Grants Project

Homestake Mining Company of California

**Re: Response to “U. S. Nuclear Regulatory Commission Review of Homestake Mining Company of California’s Reply to “Response to the Homestake Mining Company of California Letter, Dated July 26, 2018: Proposed Adjustment in Groundwater Monitoring of the San Andres-Glorieta Aquifer Near the Grants Reclamation Project”, Dated January 23, 2020, Docket No. 040-08903, License No. SUA-1471**

FIGURE 1. MIDDLE CHINLE URANIUM CONCENTRATIONS 1982

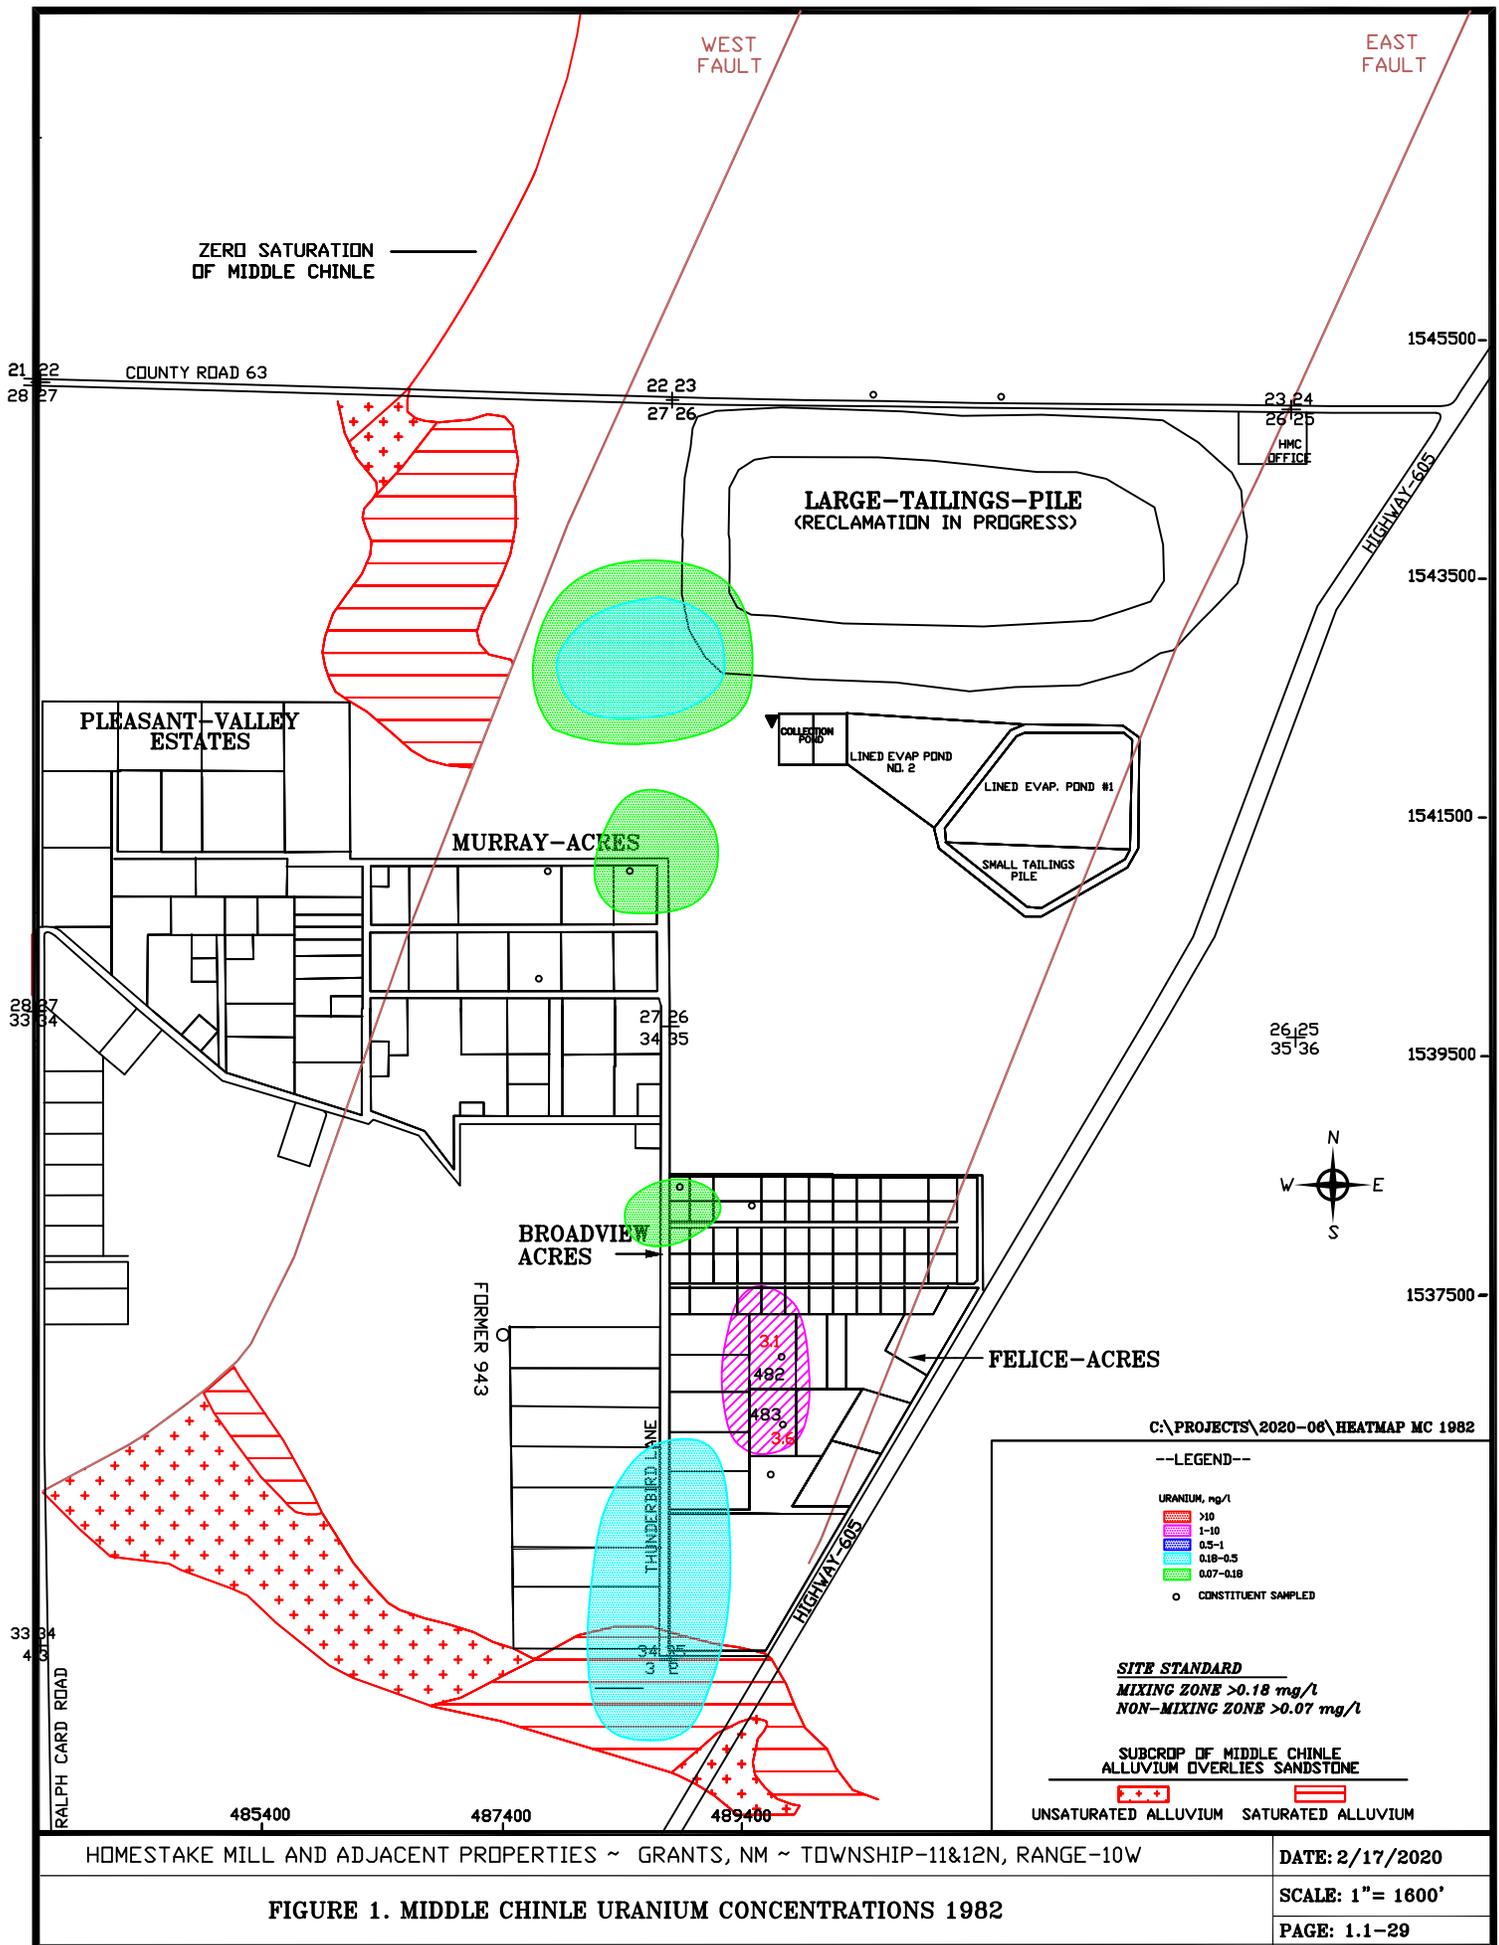
The higher uranium concentrations in the Middle Chinle aquifer in northern Felice Acres is a likely source for the higher uranium concentrations in the overlying aquifer at well 943. Higher uranium concentrations existed in the early 1980's in northern Felice Acres in Middle Chinle wells 482 and 483. Figure 1 shows the 1982 uranium pattern for the Middle Chinle aquifer with the addition of the wells 482 and 483 labels and the location of former well 943. The 1982 uranium concentrations of 3.1 and 3.6 mg/L for wells 482 and 483 respectively and a pattern showing that these concentrations are above one mg/L were added to this figure. If the leakage into well 943 was causing a continual drain of 50 gpm from the Middle Chinle aquifer, this could have caused these concentrations to migrate in the Middle Chinle to the west toward well 943. As previously stated, the higher heads in the overlying aquifer would have controlled the leakage rate and the pumping of well 943 would not have appreciably changed the leakage rate.

Figure 3. Water Level Elevation Versus Time for Observation Well CW76

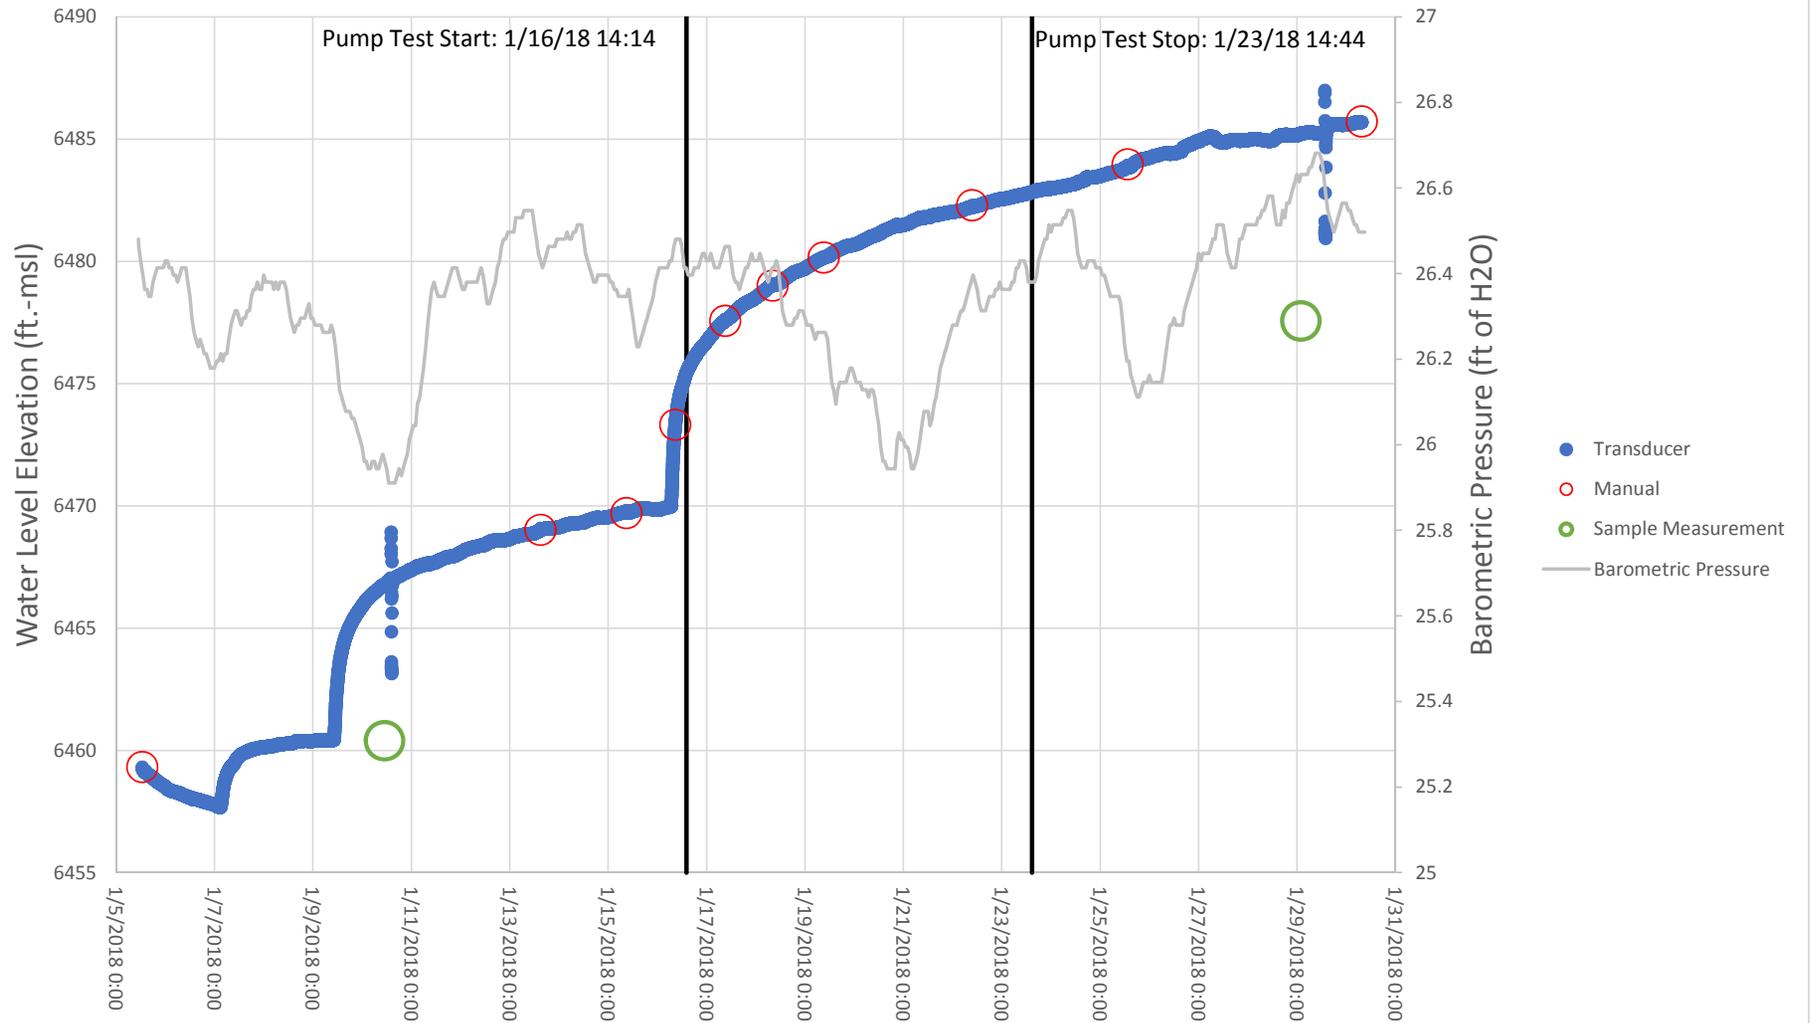
The drawdown as referenced in the RAI is likely erroneous and is artifact of either faulty equipment or technician error. Additional information on the source of the leakage is presented in the preceding response and this response discusses the cause of the alluvial water level declines. Figure 2 presents Figure 5-4 from the 943 pump test report with the addition of manual water levels (green circles) collected during sampling of this well. This data shows that the static water level measured on 1/11/2018 fits the consistent transducer water levels prior to the brief drop in water levels during sampling, while the static water level on 1/29/2018 does not fit the data. This manual water level (green circle) indicates a water level drop or drawdown in alluvial well 845 that conflicts with the transducer

and other manual water levels (red circles) taken before, during and after the sampling on 1/29/2018. For clarification, the transducer data (blue dots) during sampling of the observation wells show a vertical stringing of the water level data on the graphs indicating the rapid drawdown during pumping for sample followed by a quick recovery to near the static water level. The water level measured prior to sampling on 2/6/2018 also indicates a dramatic water level drop from the final measurements taken during the pump test or approximately five feet of apparent drawdown occurring more than 11 days after pumping of well 943 ended. The static water levels measured during sampling events for Middle Chinle well CW76 (Figure 3), Lower Chinle well V1 (Figure 4) and San Andres well 943M (Figure 5) are also significantly lower than the corresponding transducer and pump test manual water level measurements. It should be noted that the water level monitoring during the pump test was performed by professional contractor staff and senior HMC personnel while the observation well water sampling was performed by HMC's technical staff. The consistency of the transducer data (blue dots) and the manual water levels (red circles) collected during the test reflects the careful and consistent use of the same water level measurement equipment throughout the test. In contrast, water level measurement equipment used during sampling (green circles) may have differed during the multiple sampling events depending on the assigned technical staff. Therefore, the significantly lower sampling water level measurements are very likely errors and are not a correct representation of water levels in these wells. These erroneous water levels were likely caused by use of a malfunctioning or improperly repaired or corrected water level measurement instrument during specific sampling events or cycles.

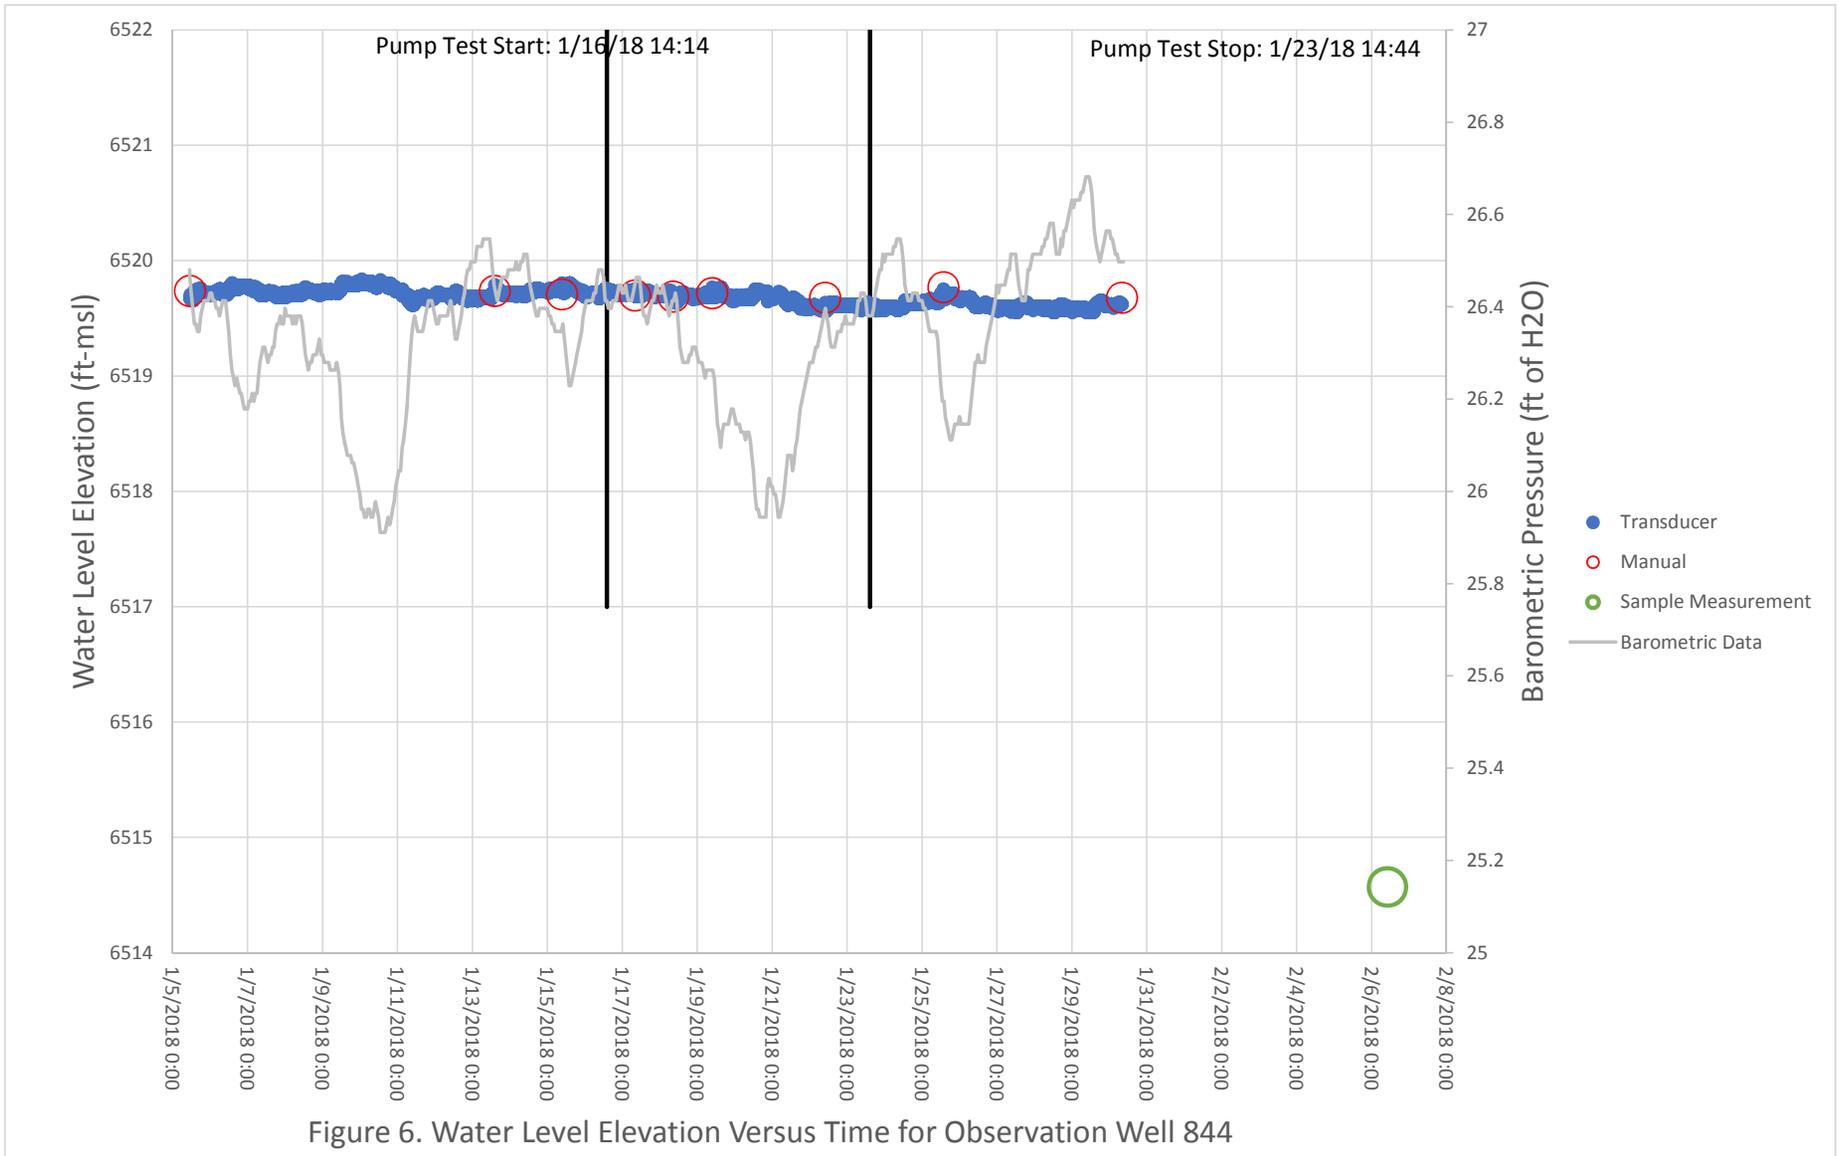
Alluvial water levels in the well 943 area were also monitored with a transducer in alluvial wells 844 and 556 (see Figures 6 and 7) and the static water levels measured during sampling events on 2/6/2018 also indicate apparent drawdown in these areas of the alluvial aquifer. These sampling water level data indicate roughly five feet of apparent drawdown occurring in the alluvial aquifer out to a distance of 1800 feet from well 943 approximately 11 days after pumping of well 943 ended. A simple calculation of aquifer storage reveals that this amount of water level drop over a circle with a radius of 1800 feet and a specific yield of 0.2 would yield roughly 28 times the amount of water that was pumped during the 943 pump test. Also, these indicated drawdowns in the alluvial aquifer are greater than the drawdown observed in pumping well 943. Static water levels measured during February 2018 sampling events in the 100-Acre Center Pivot area wells were also lower by a similar amount, and these wells are located more than a mile from the former well 943 location. All of these lower water levels are thought to be an error in the water level measurements associated with specific sampling cycles and were likely taken with a specific water level measurement instrument. The circumstances of the water level measurements in question indicate they are not plausibly delayed drawdown from the 943 pumping, and it was a coincidence that the erroneous measurements occurred shortly after the well 943 pump test. It should also be noted that the water levels in the affected wells returned to the range of normal static water level for subsequent measurements, further buttressing the interpretation that the measurements were erroneous.
